Rezoning Transportation Analysis

Petition Number: 2020-067

General Location Identifier: Tax ID 09505544

Date	Description
05-18-20	First Review

Reference (CLDSM standard detail U-03A) for street typical.

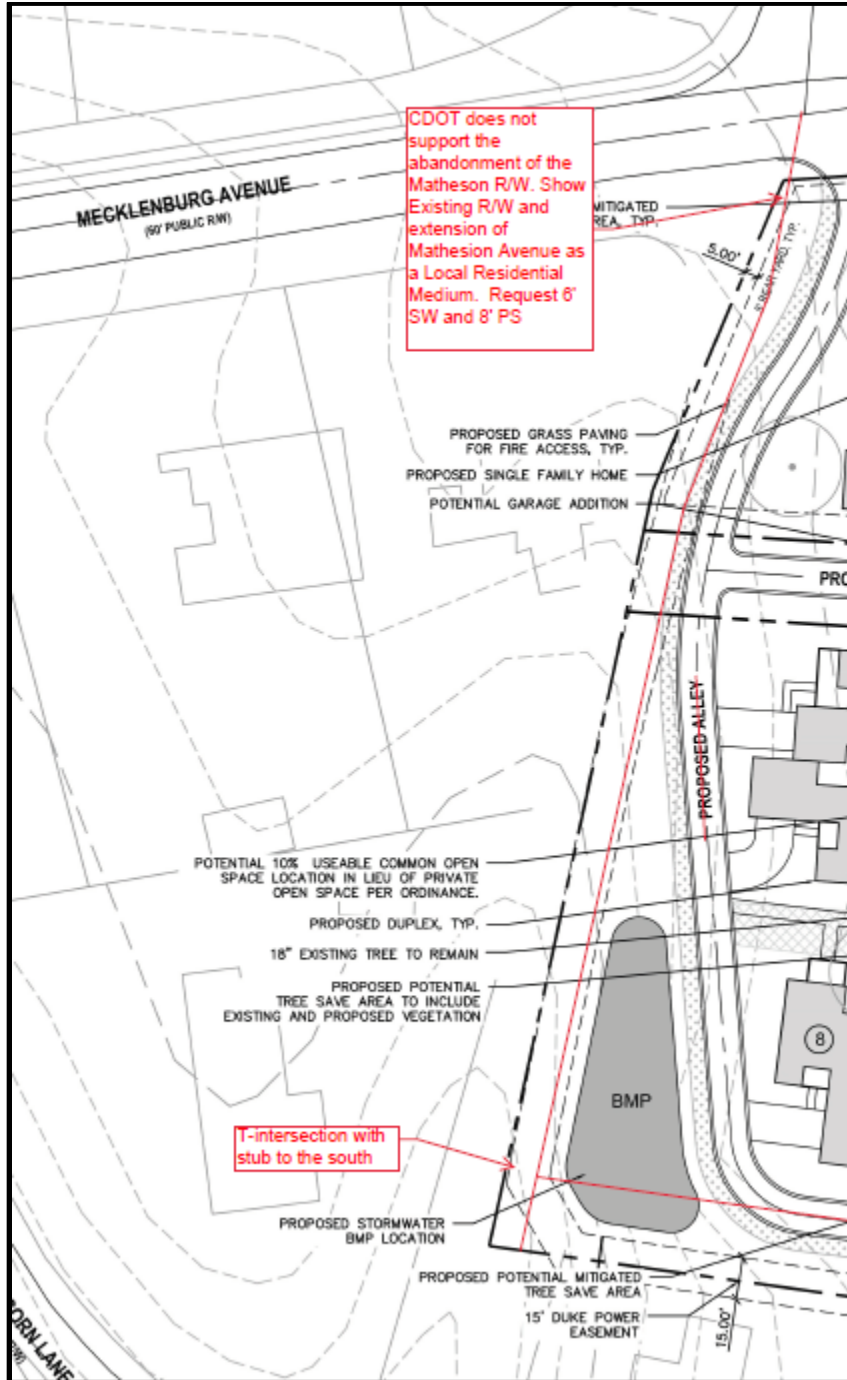
- The petitioner should revise the site plan and conditional note(s) to commit to constructing a public street, Matheson Avenue south of Mecklenburg Avenue, as a Local Residential Medium with an 8-foot planting strip, and 6-foot sidewalk per Chapter 20 Subdivision ordinance.
